SHADOW RIDGE ADDITION

RE: SUB 2002-65 -- Final Plat of Shadow Ridge Addition

At the regular meeting of the Subdivision Committee of the Metropolitan Area Planning Commission on Thursday, September 19, 2002, the above captioned plat was considered. The action of the Committee was to approve the final plat, subject to the following:

CASE NUMBER: SUB 2002-65 -- SHADOW RIDGE ADDITION

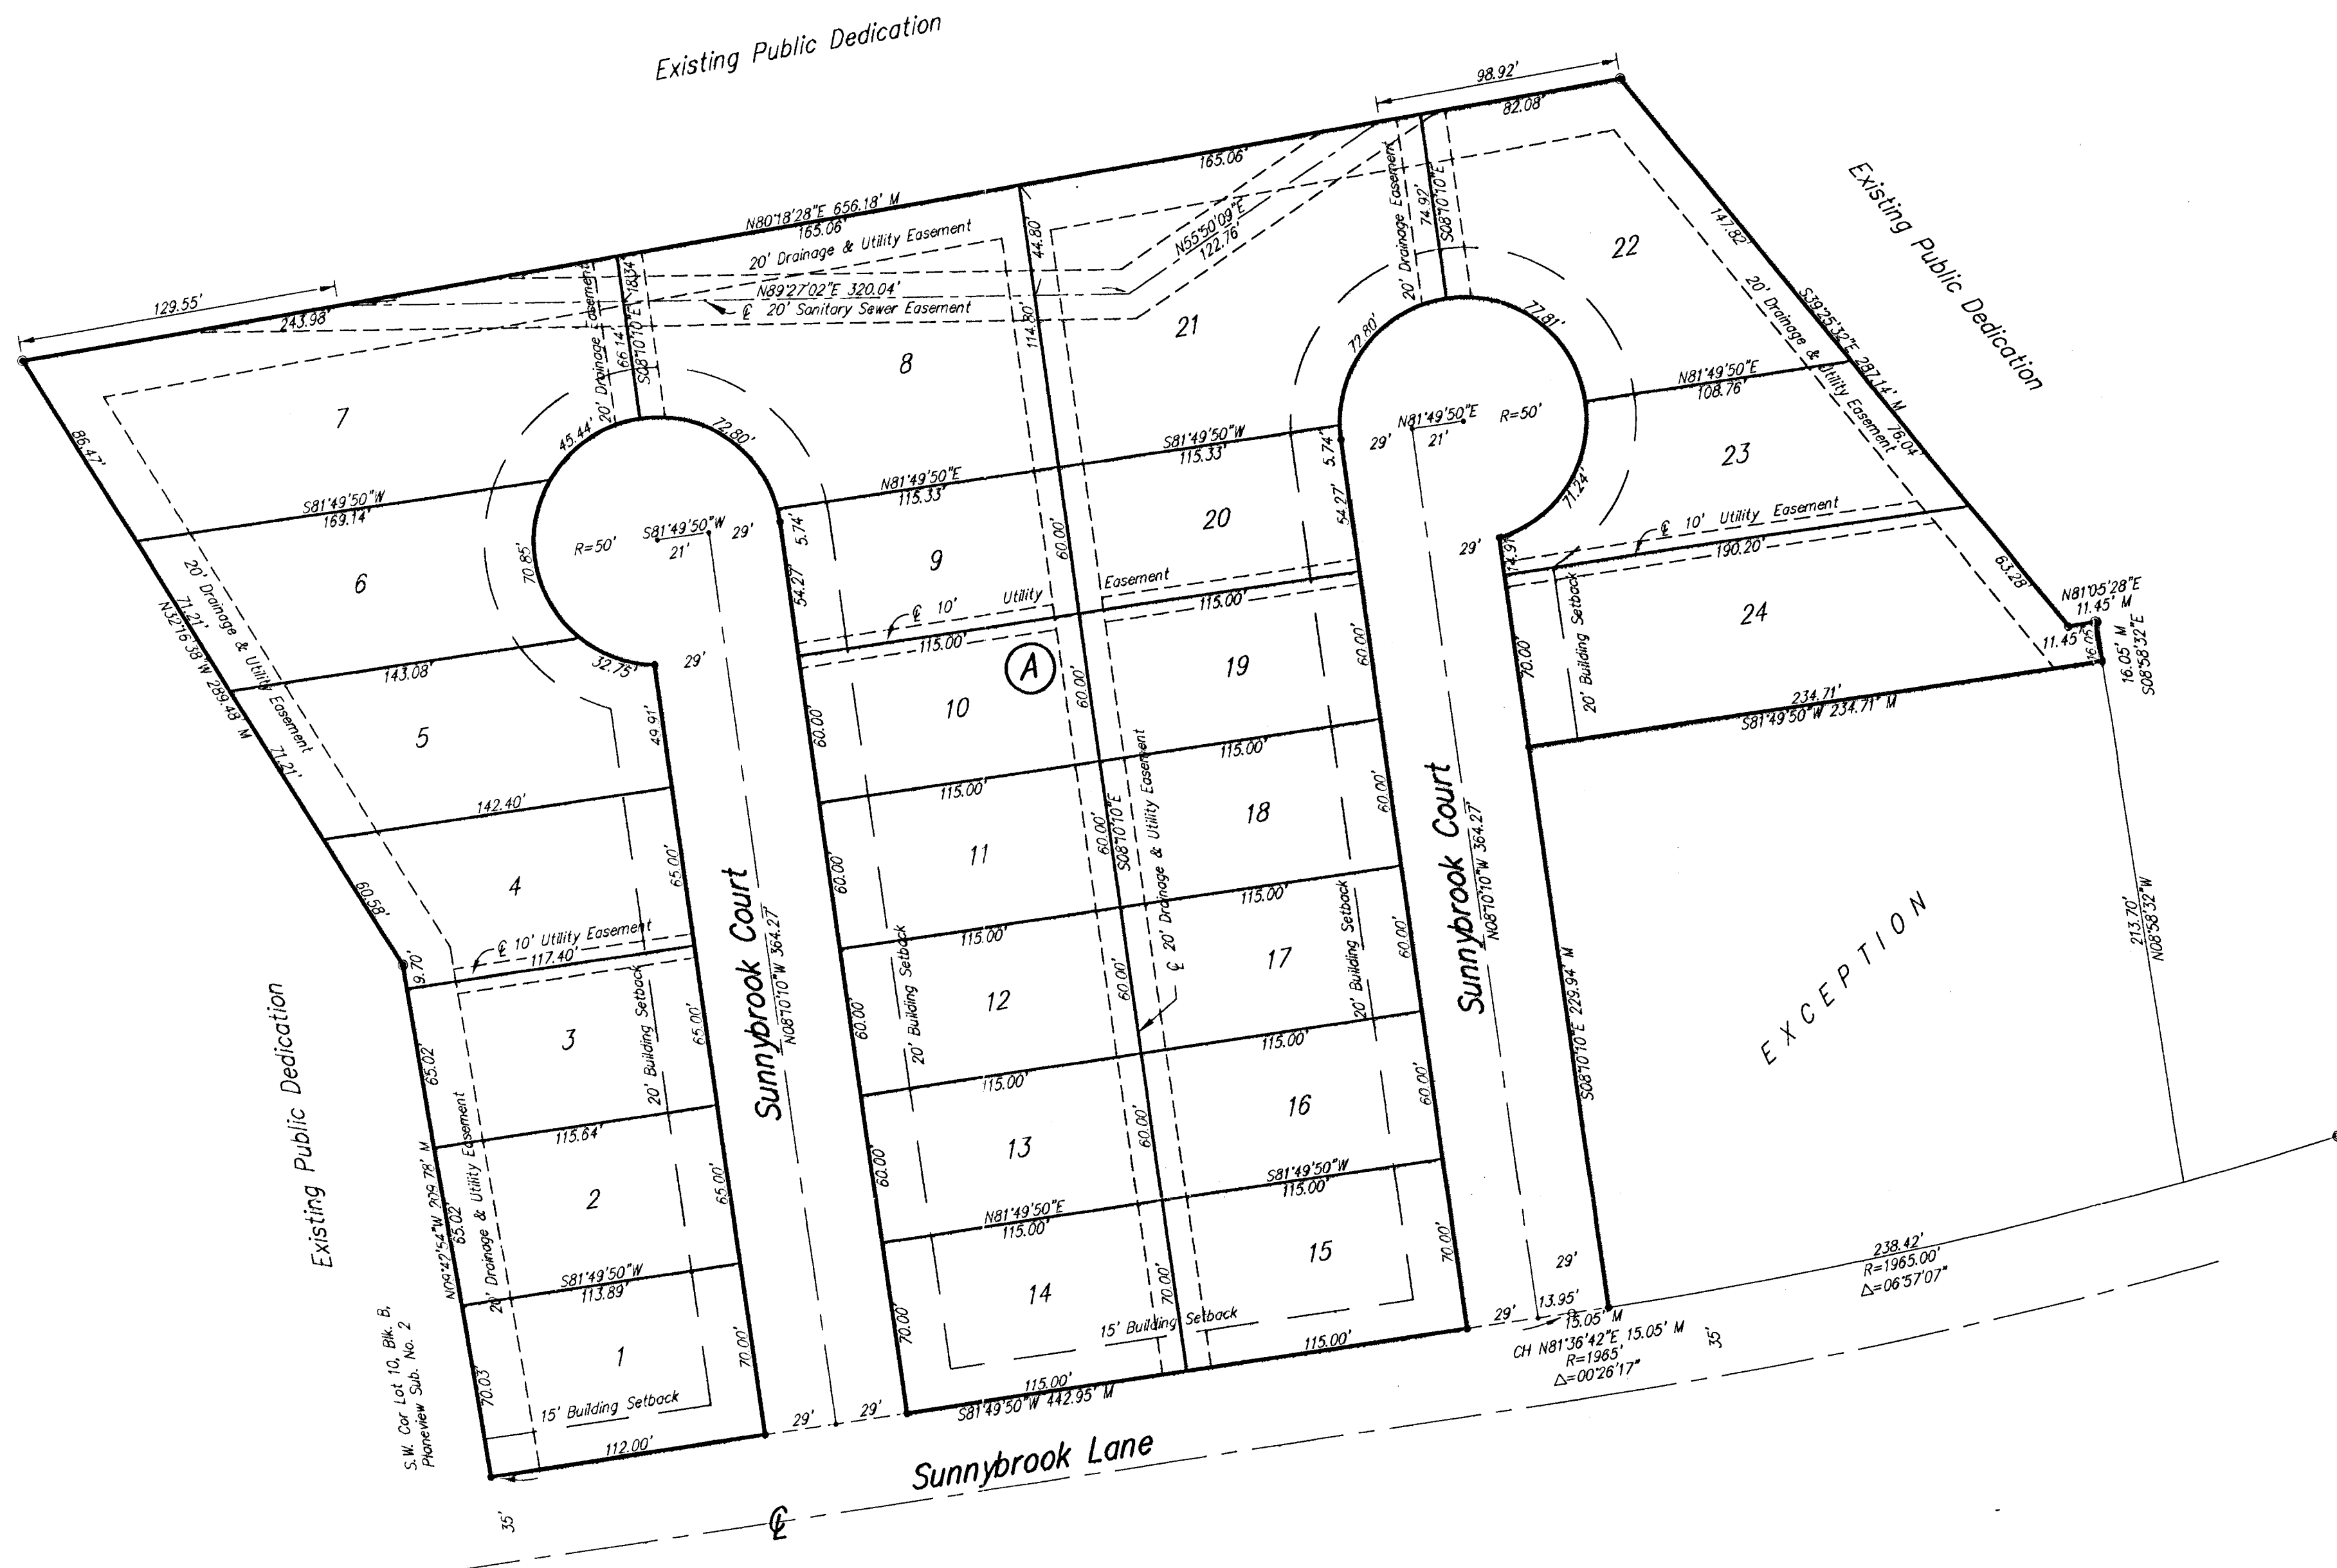
- C. City Engineering needs to comment on the status of the applicant's drainage plan. **A revised drainage plan is needed. Drainage improvements are required which may be a part of the street paving guarantee.**

- D. The platting text in the final plat shall note the dedication of the streets to and for the use of the public.
- E. The Subdivision Regulations require street jogs of local streets to be 150 feet or greater between centerlines. **A modification has been approved for the 80-ft street jog between Sunnybrook Lane and Clifton (extending south of Sunnybrook Lane) which is less than the required 150 feet.**

- F. Due to the 58-ft streets, a zone change to SF-5, Single-Family District is needed. In the alternative, a restrictive covenant is needed limiting the site to single-family development. **The applicant intends to provide a restrictive covenant.**

- H. The Applicant has platted 20-ft front building setbacks and 15-ft street side setbacks which represents adjustment of the Zoning Code standard of 25 feet and 20 feet respectively for the MF-29, Multi-family District. The Subdivision Regulations permit the setback provisions to be modified by the plat upon the approval of the Planning Commission. The Subdivision has recommended that a modification be granted.

- I. The City Fire Department/GIS needs to comment on the plat's street names. The street names are approved.
- J. Approval of this plat will require a waiver of the lot depth to width ratio of the Subdivision Regulations for Lots 7 and 24. The Subdivision Regulations state that the maximum depth of all residential lots shall not exceed 2.5 times the width. The modification has been approved.

- K. On the final plat tracing, the MAPC signature block needs to reference "Michael E. Lindebak, Secretary".
- L. On the final plat tracing, the MAPC signature block needs to reference "Bernard A. Hentzen, Chair".

- N. The platator's text shall include language that a drainage plan has been developed for the plat and that all drainage easements, rights-of-way, or reserves shall remain at established grades or as modified with the approval of the applicable City or County Engineer, and unobstructed to allow for the conveyance of stormwater.

- V. The representatives from the utility companies should be prepared to comment on the need for any additional utility easements to be platted on this property. Westar Energy requests additional easements.
